**PROPOSED 'PLACE OF RECREATION, SPORTS OR CULTURE
(PUBLIC RIDING SCHOOL WITH ANCILLARY FACILITIES)' AT
THE RESTORED LANDFILL SITE (TKOL II/III)
IN TKO AREA 105, TSEUNG KWAN O (GLA TSK-500)
(TPB No. A/TKO/134)**

RESPONSES-TO-COMMENTS TABLE

PROPOSED PLACE OF RECREATION, SPORTS OR CULTURE (PUBLIC RIDING SCHOOL) WITH ANCILLARY FACILITIES AT GOVERNMENT LAND IN D.D. 233, THE RESTORED LANDFILL SITE (TKOL II/III) IN TKO AREA 105, TSEUNG KWAN O (GLA TSK-500 (PART)) [TPB REF: A/TKO/134]

Indicative Master Layout Plan

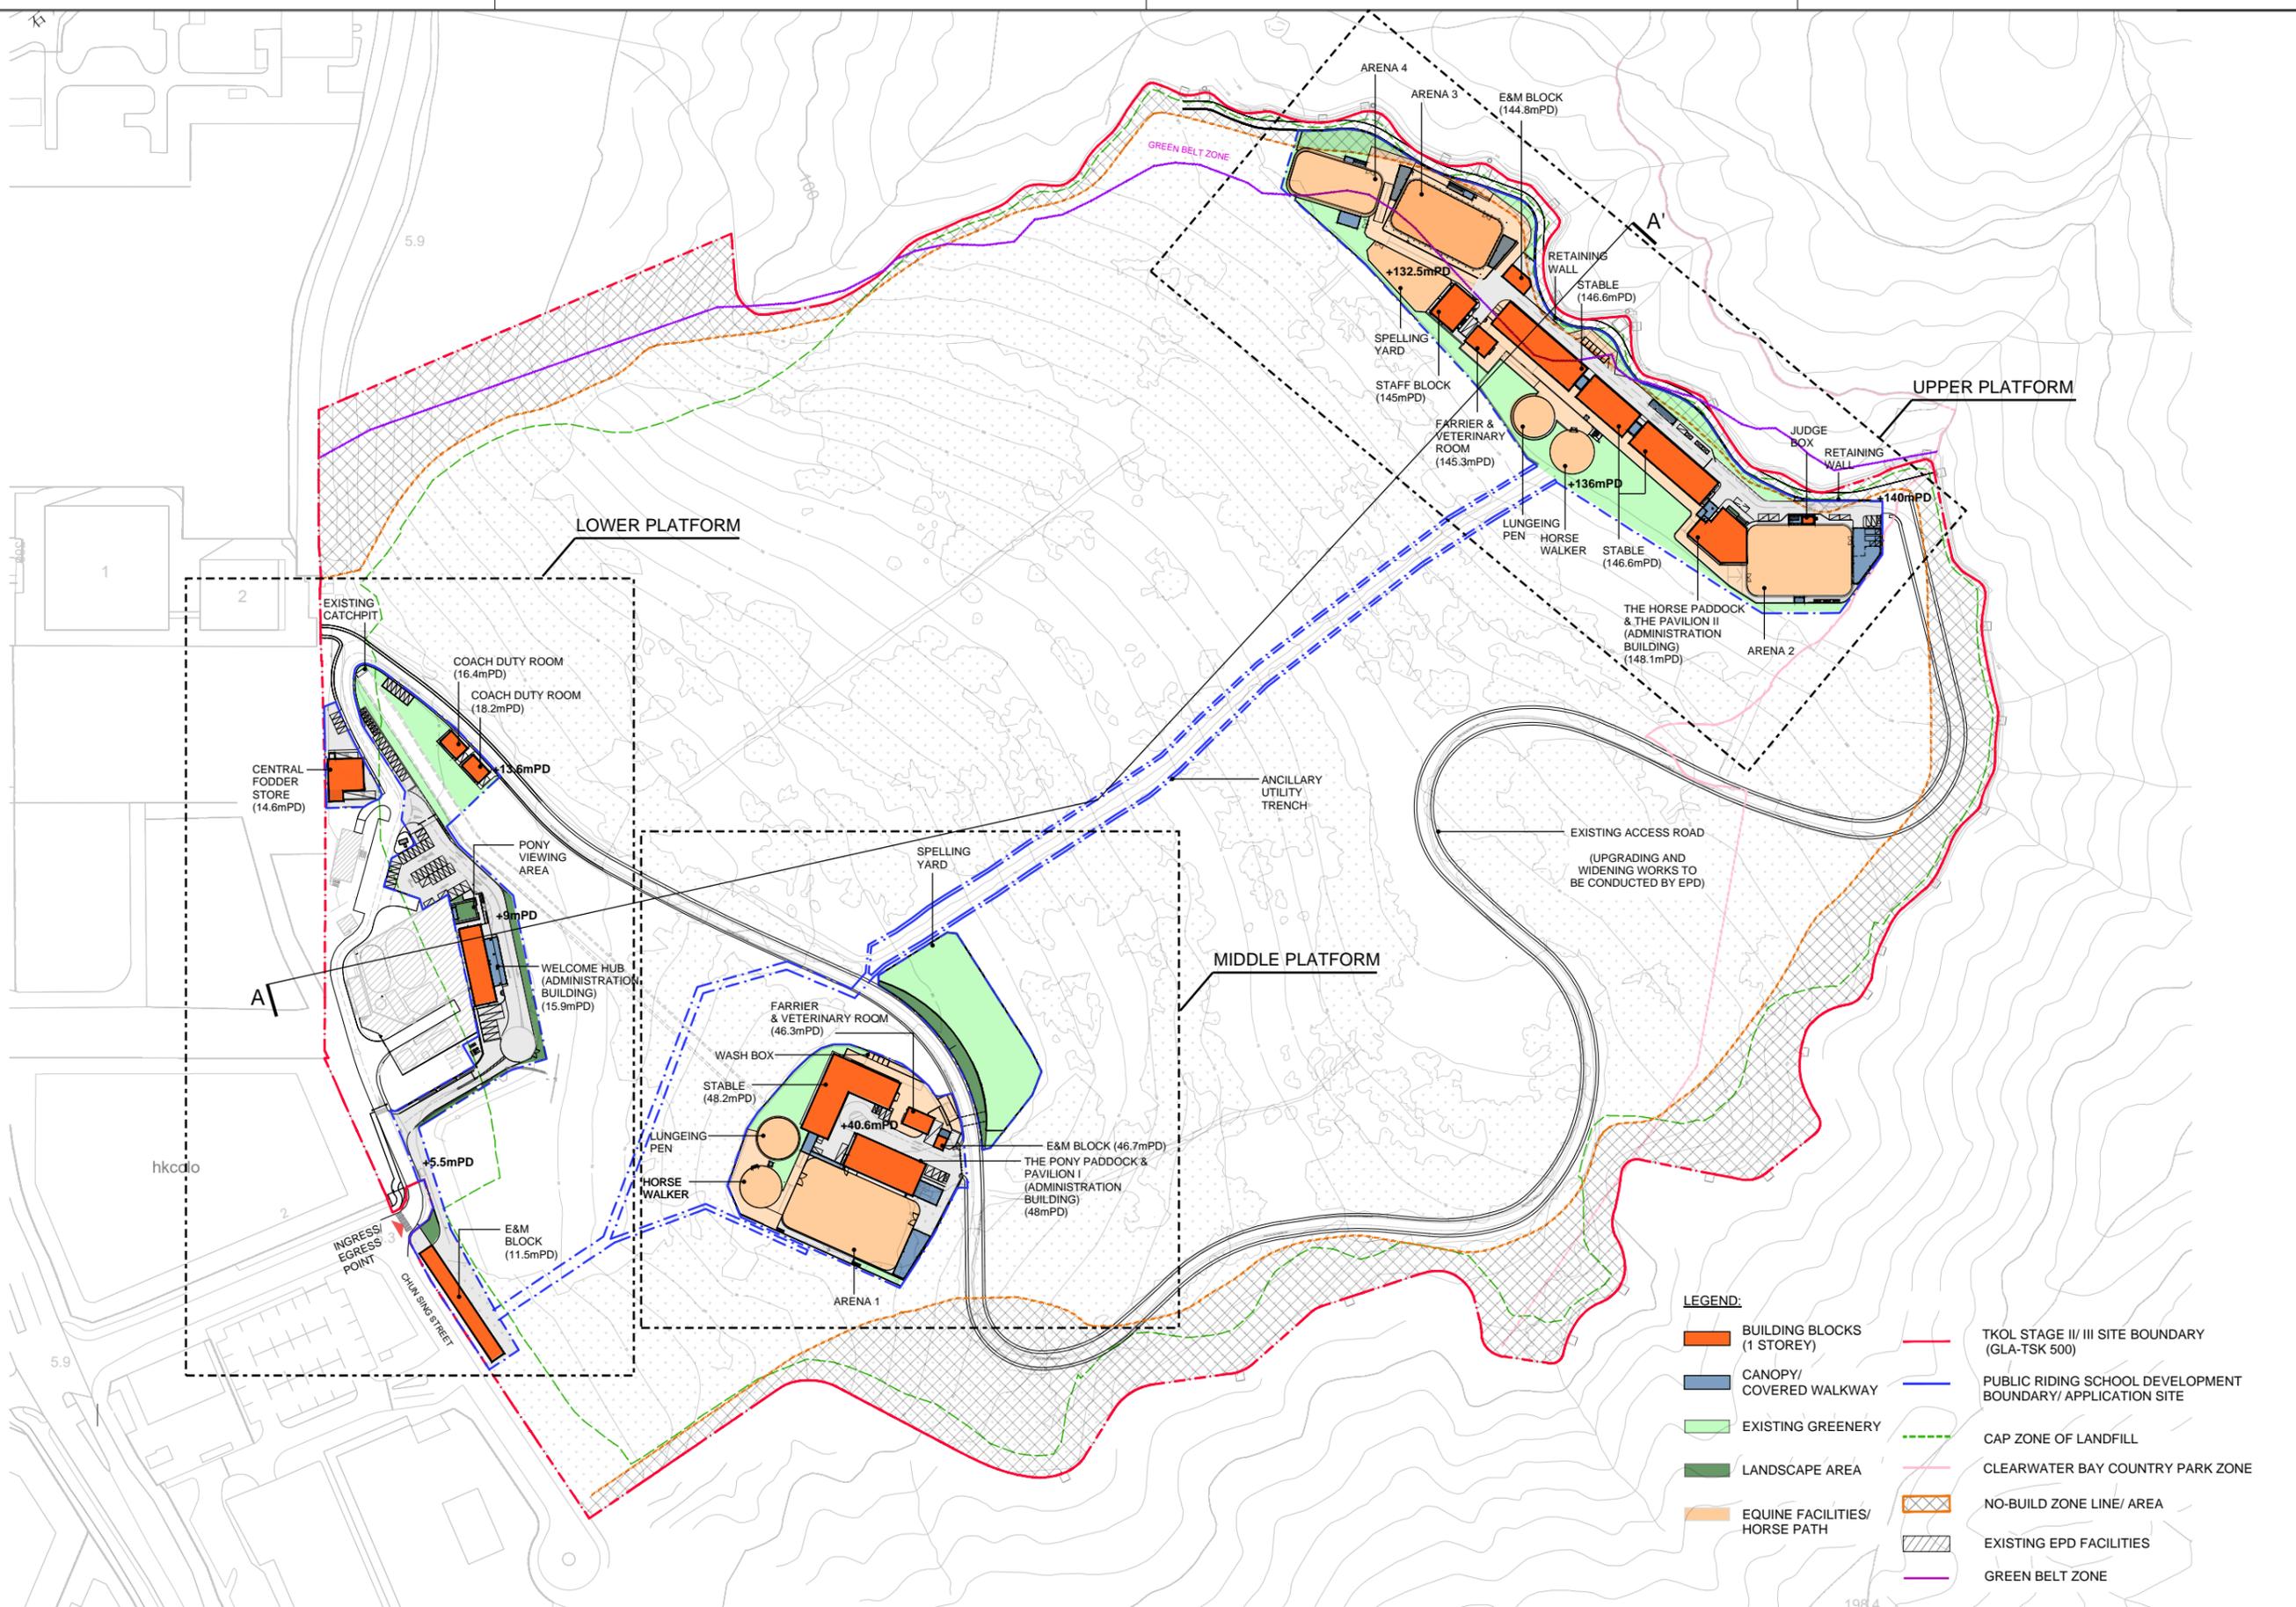
1.	Noting that two coach duty rooms are regarded as domestic use, please clarify its function and how many staff will be accommodated;	Please be advised that the two (2) Coach Duty Rooms are designated for staff and supporting members to stay on a 24/7 basis. In addition to the daily care and welfare of the horses and ponies, they will also remain on-site during non-operational hours to perform emergency duties. Each of two (2) Coach Duty Rooms will accommodate 2 to 4 staff along with supporting members. Please also be clarified that the building height of the "Coach Duty Room" at the Lower Platform is <u>4.5m</u> . Please refer to the replacement pages to the SPS and the revised Appendix 1: Conceptual Architectural Drawings and Indicative Artist's Impression in Attachments 3 and 6 respectively.
